## Development Review Division

### MEMORANDUM

**TO:** Ryan Amato, EVT Parker Colorado, LLC  
**FROM:** Ryan McGee, AICP, Associate Planner  
**DATE:** October 27, 2017  
**SUBJECT:** 1<sup>st</sup> submittal of Site Plan for Parker Auto Plaza Filing No. 1, Block 3, Lot 1 (Planning Case No. SP17-073).

SP17-073; Parker Auto Plaza Filing No. 1, Block 3, Lot 1

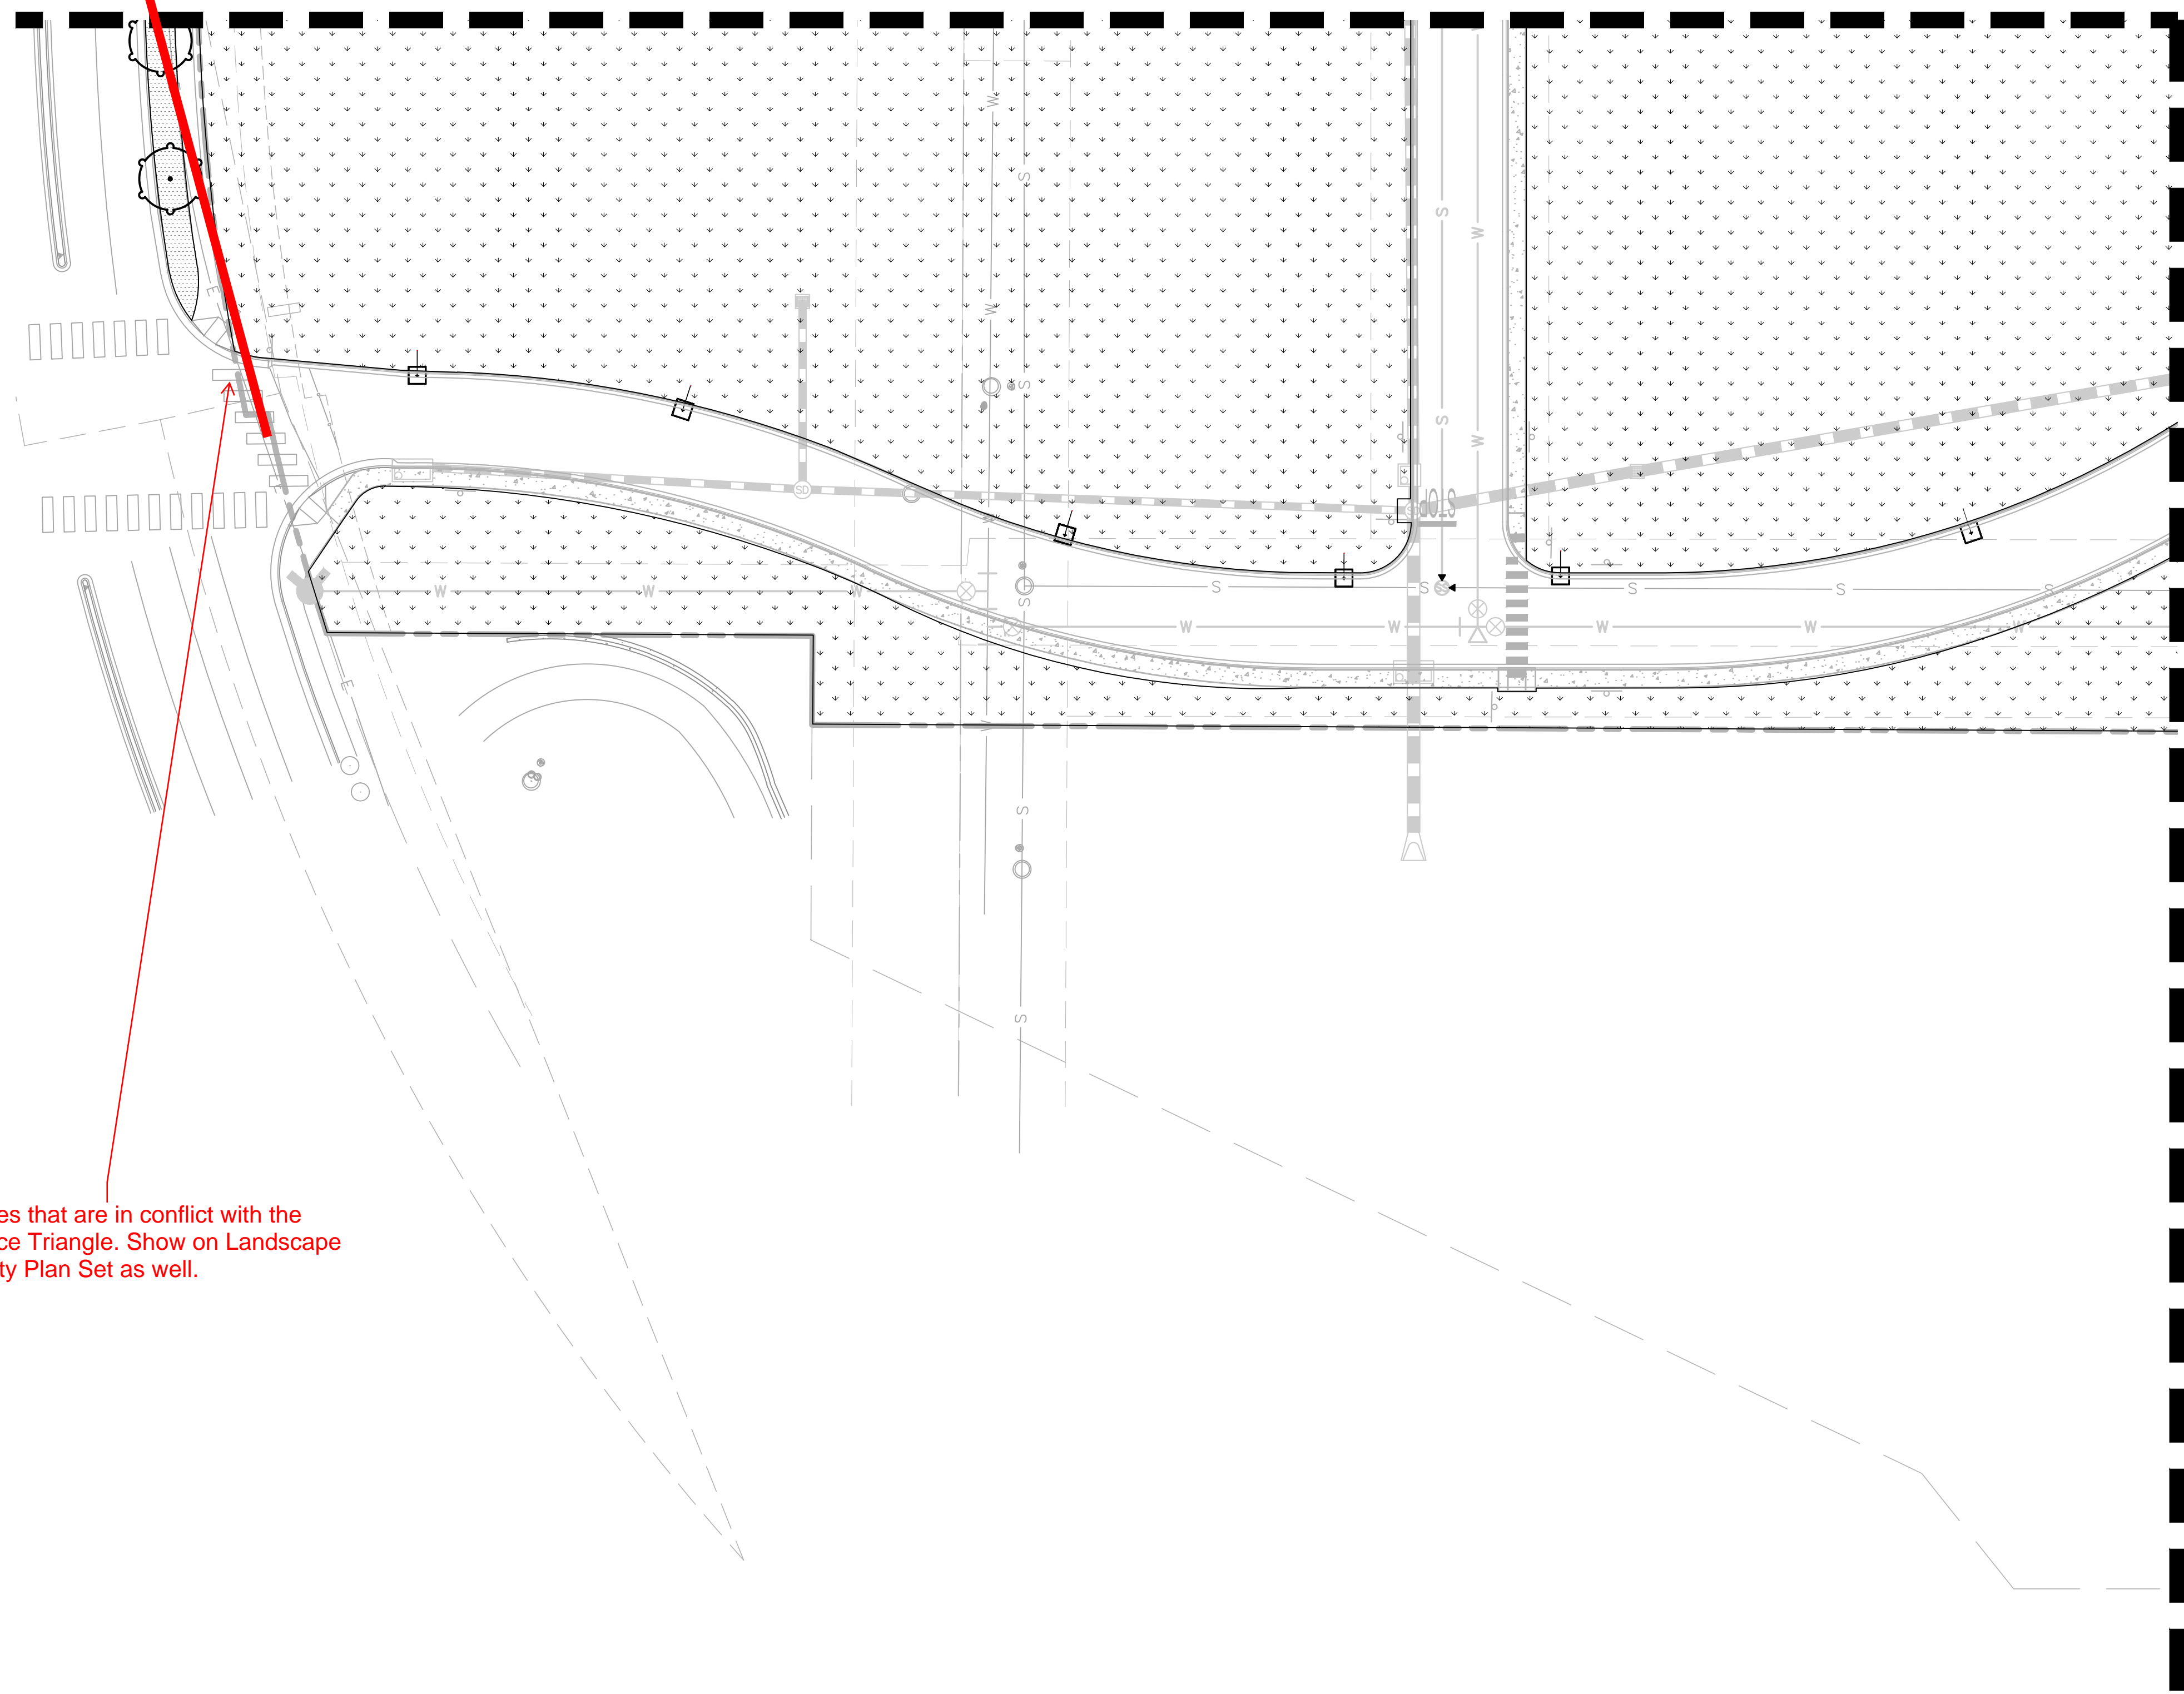
Relocate trees that are in conflict with the Sight Distance Triangle. Show on Landscape Plans in Utility Plan Set as well.

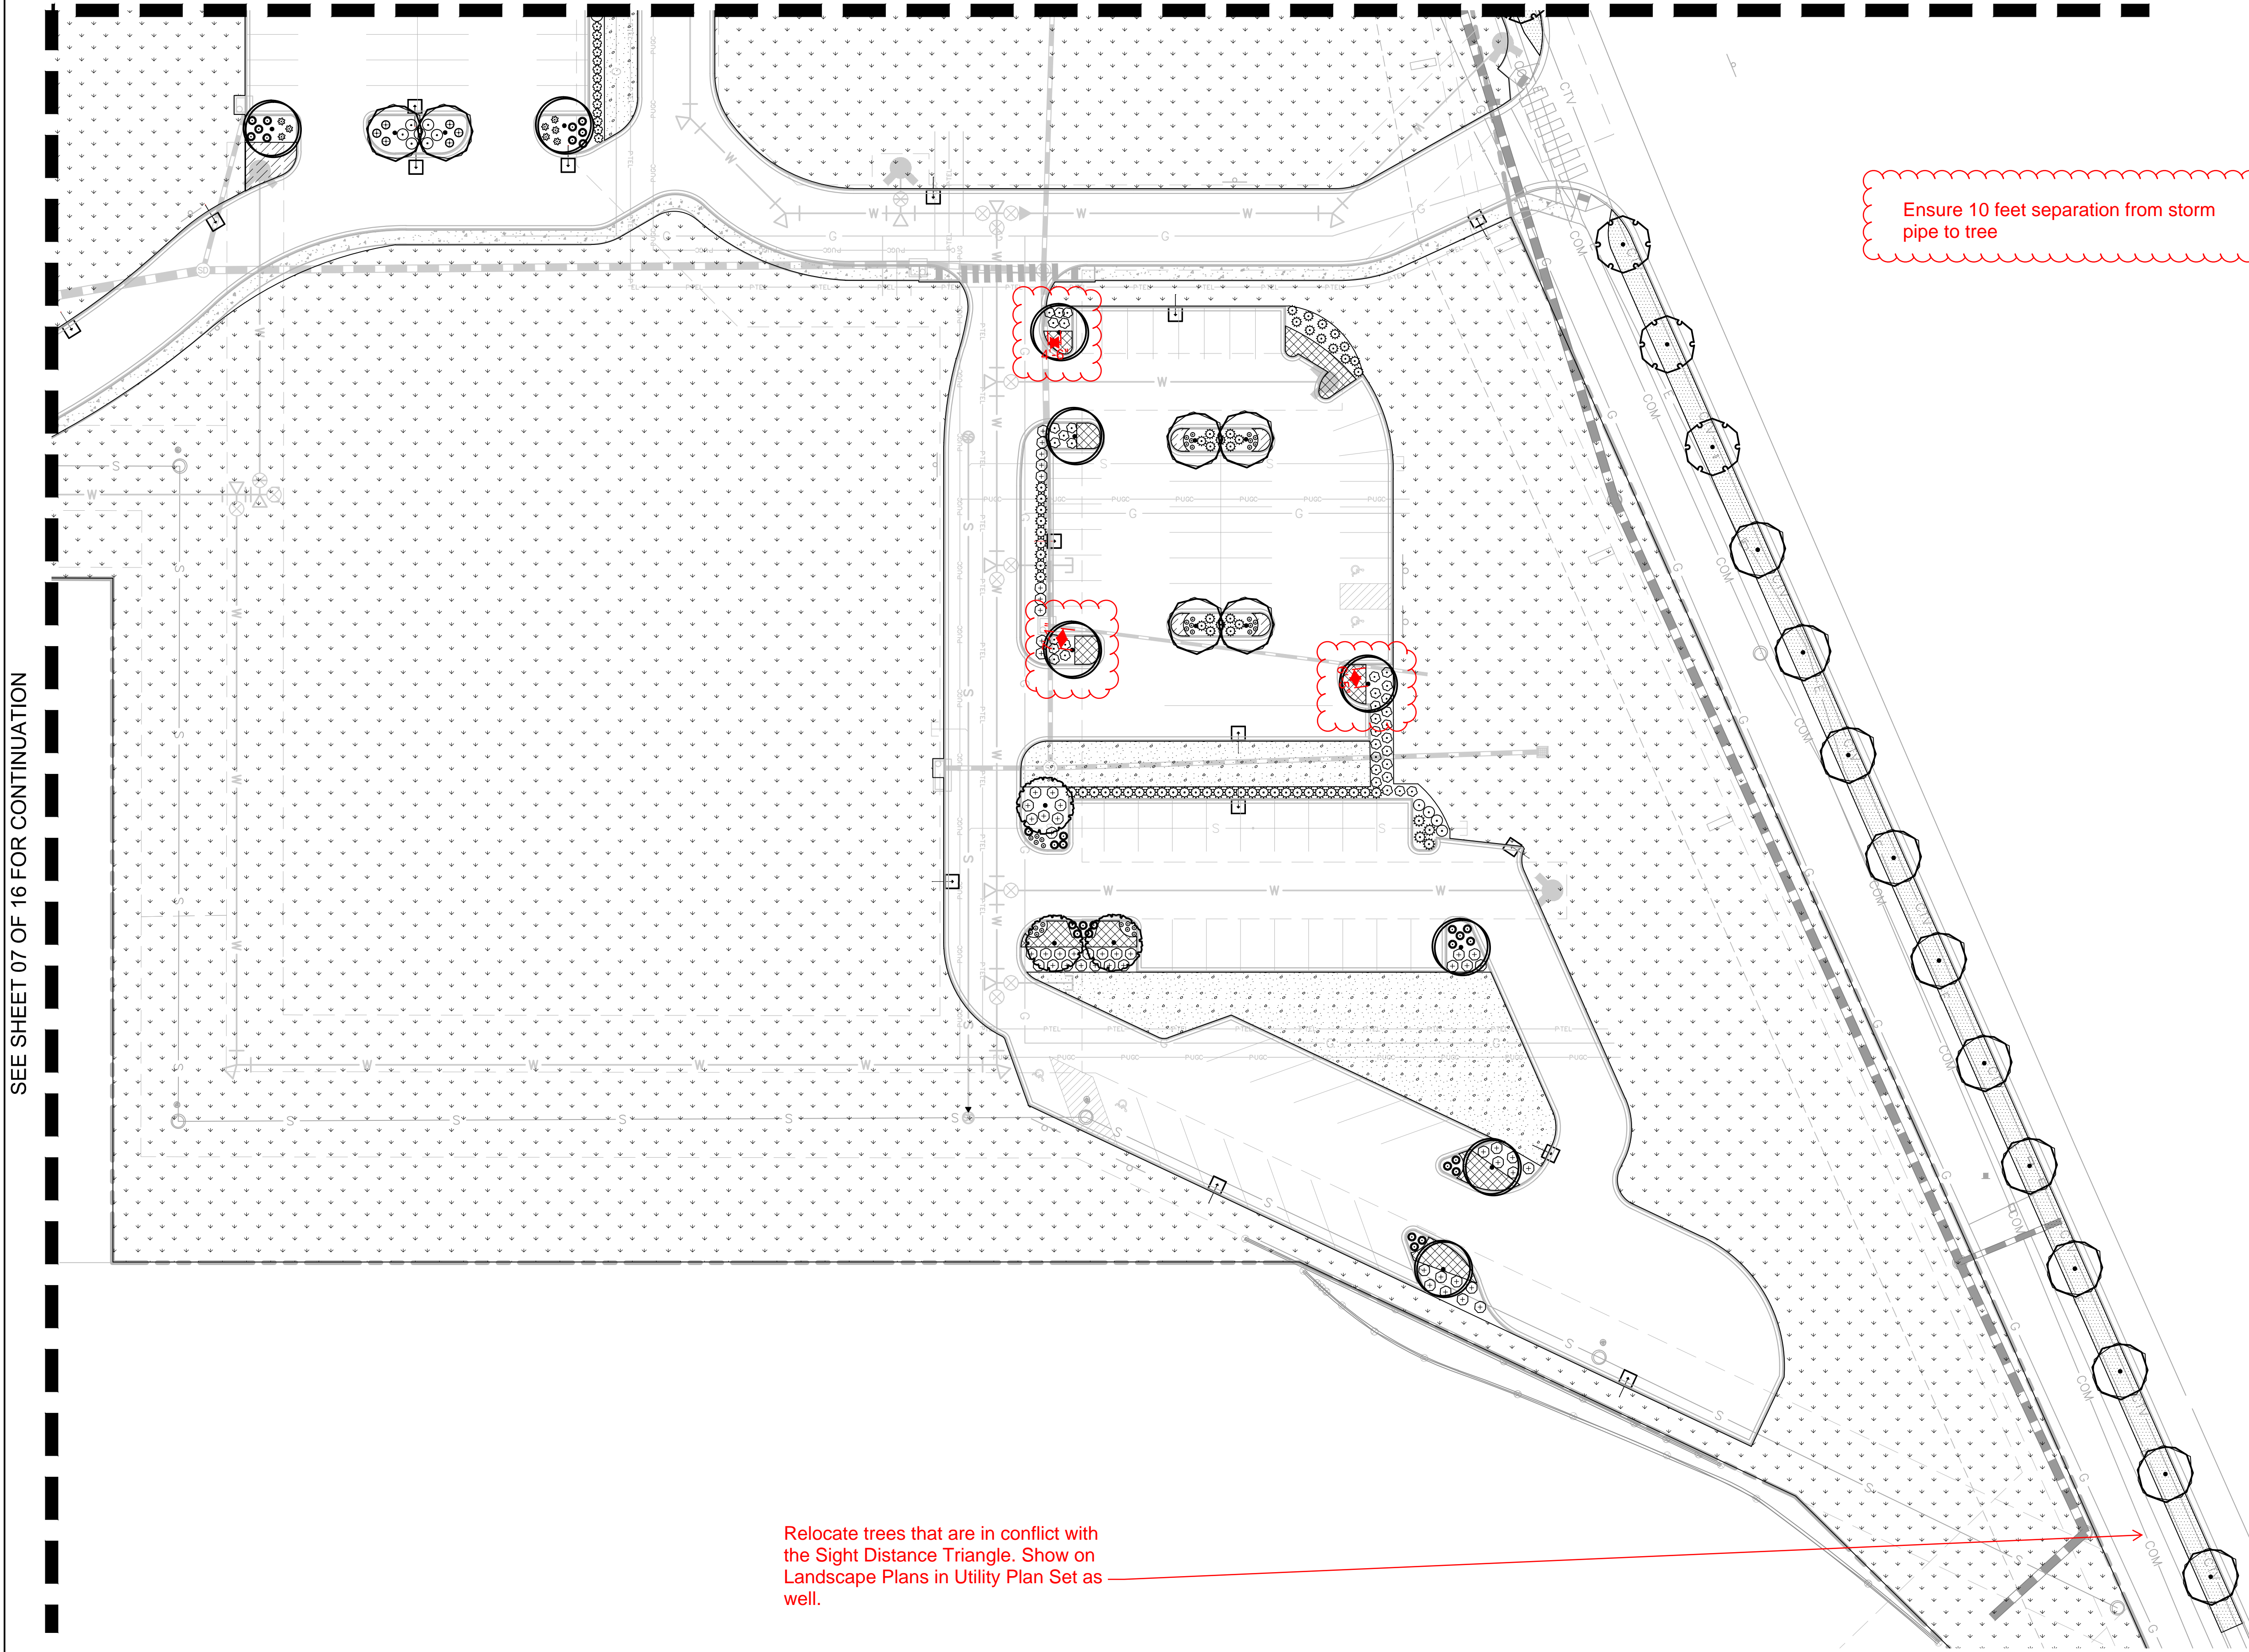
Relocate trees that are in conflict with the Sight Distance Triangle. Show on Landscape Plans in Utility Plan Set as well.

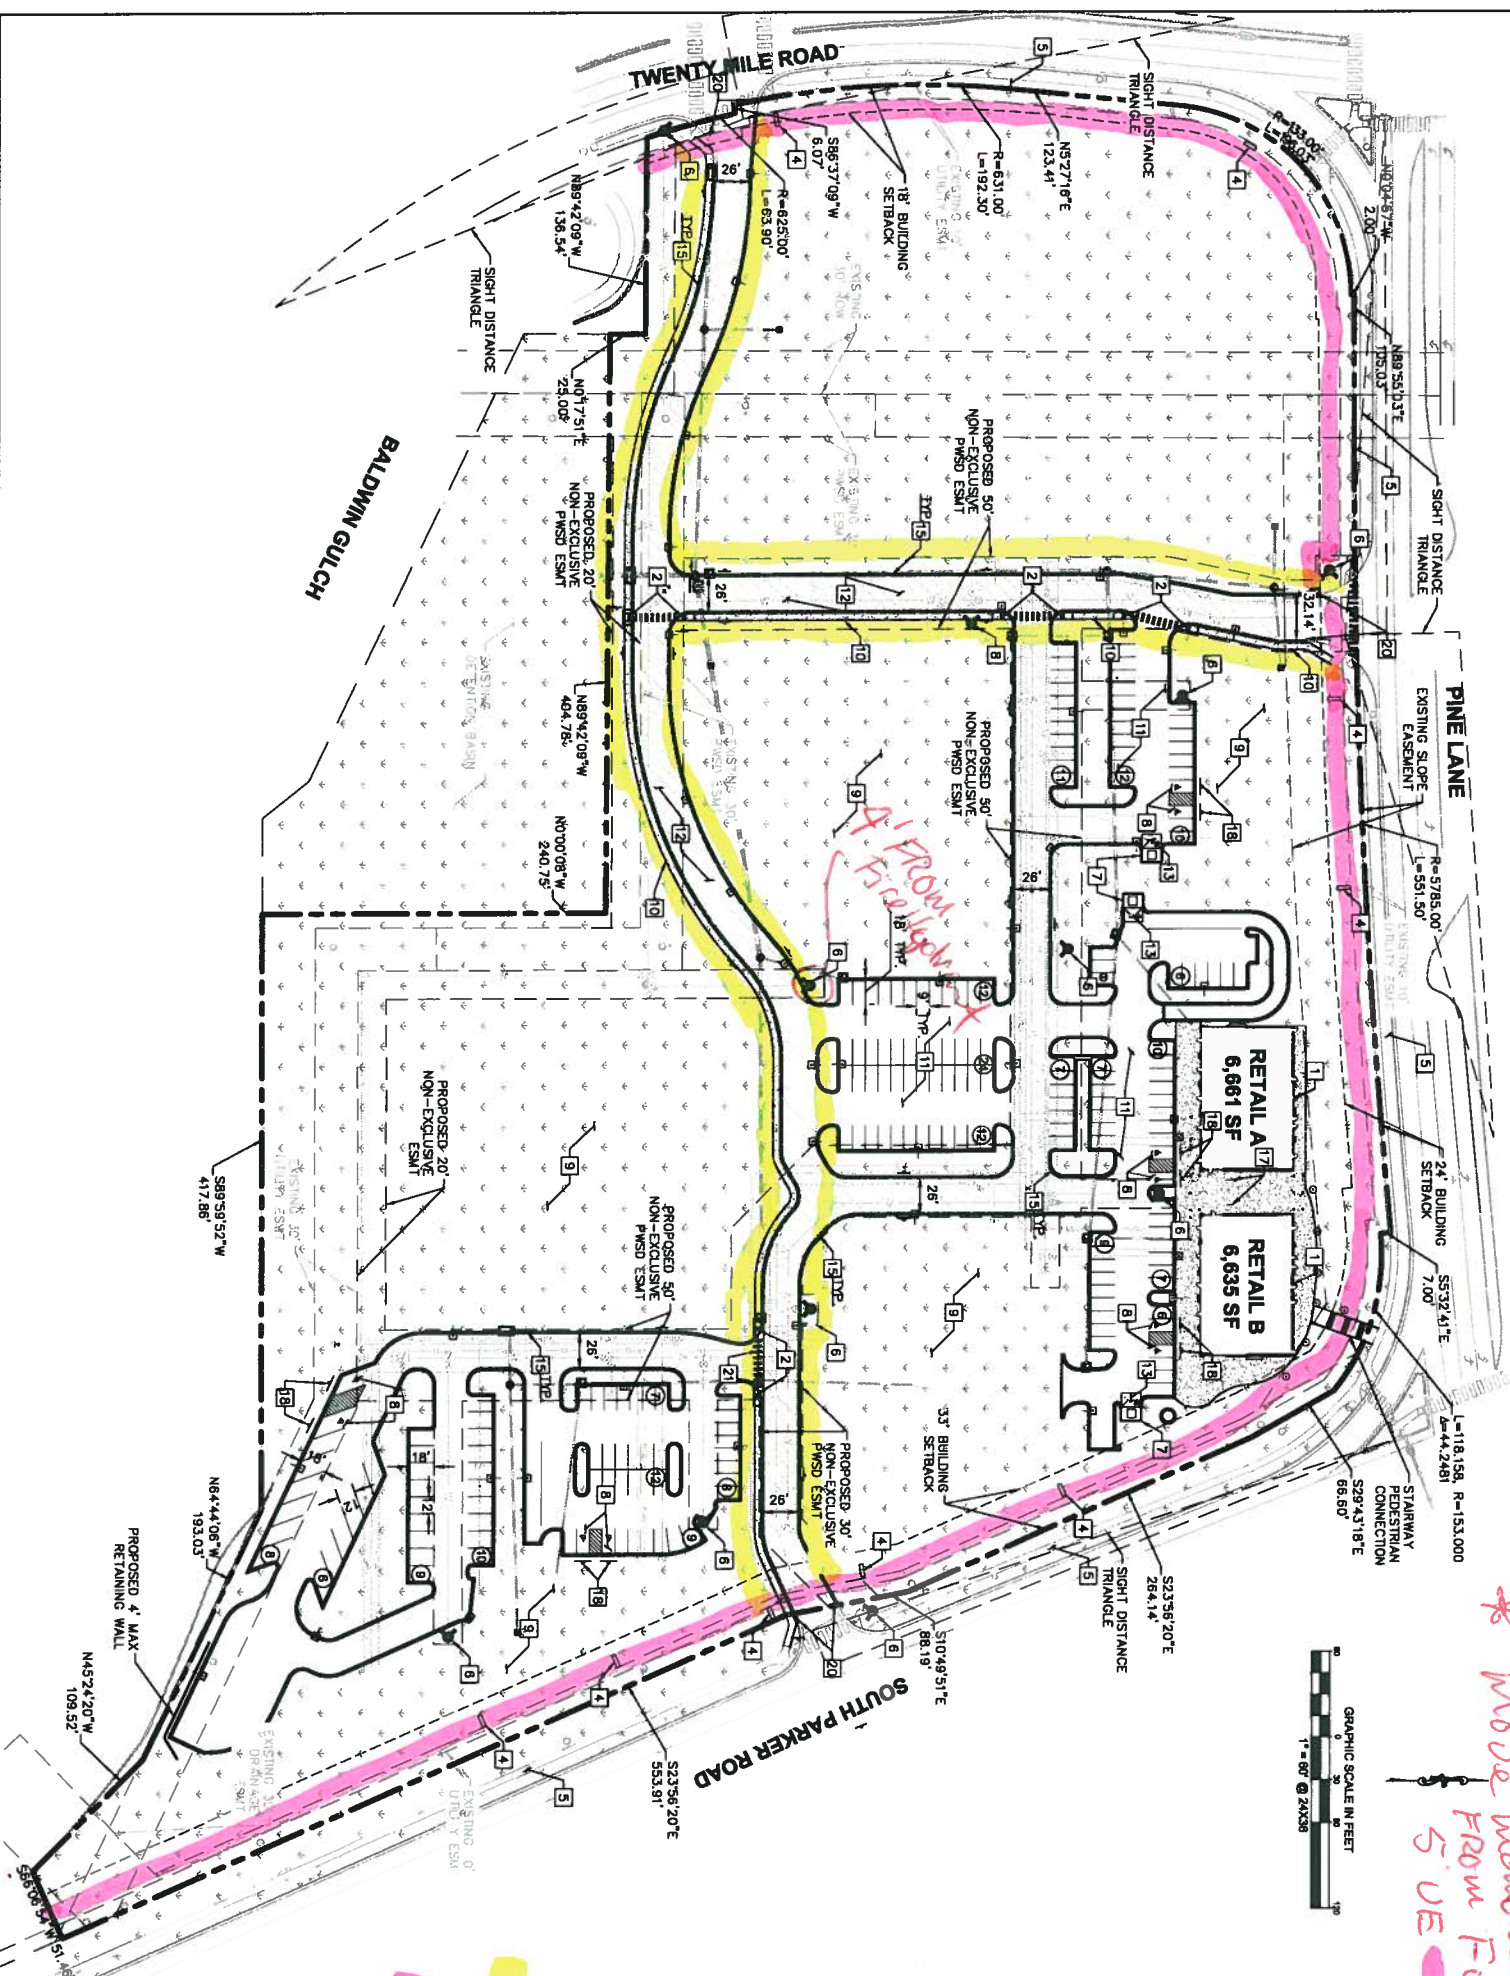
*\* Show transitions  
locations  
\* Move monuments  
FROM FUTURE  
5' UE*
